SB, New Trigger and Display, K7000 family, 2023-05

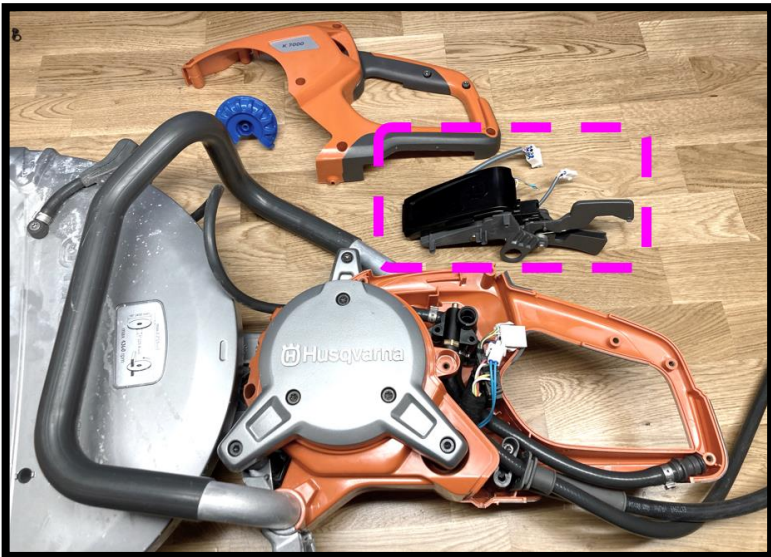
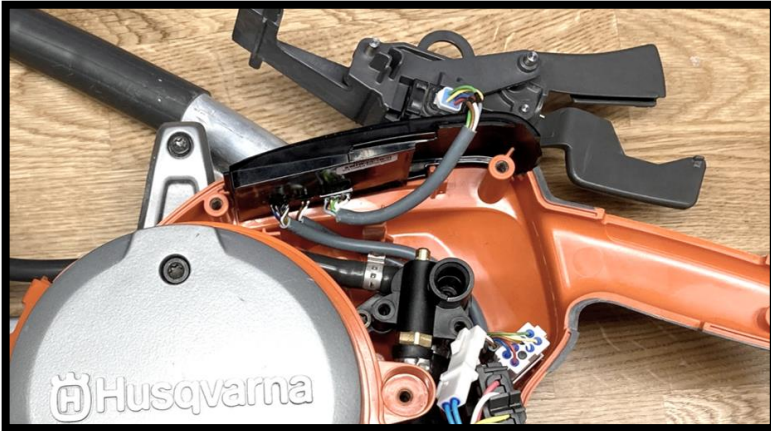
Field reports have shown that the trigger on the K7000 family fails prematurely. To fix this issue we have implemented a new, more robust trigger. Due the new design of the trigger the display is also changed. In addition, a new console to hold the trigger is implemented.

New individual parts are not backwards compatible with old individual parts.

If a trigger or a display needs to be changed on a K6500 family or a K7000 before serial no: 20232000001, an upgrade kit needs to be ordered. The upgrade kit includes all parts (new trigger, new display and new console) needed to upgrade the product to the new trigger.
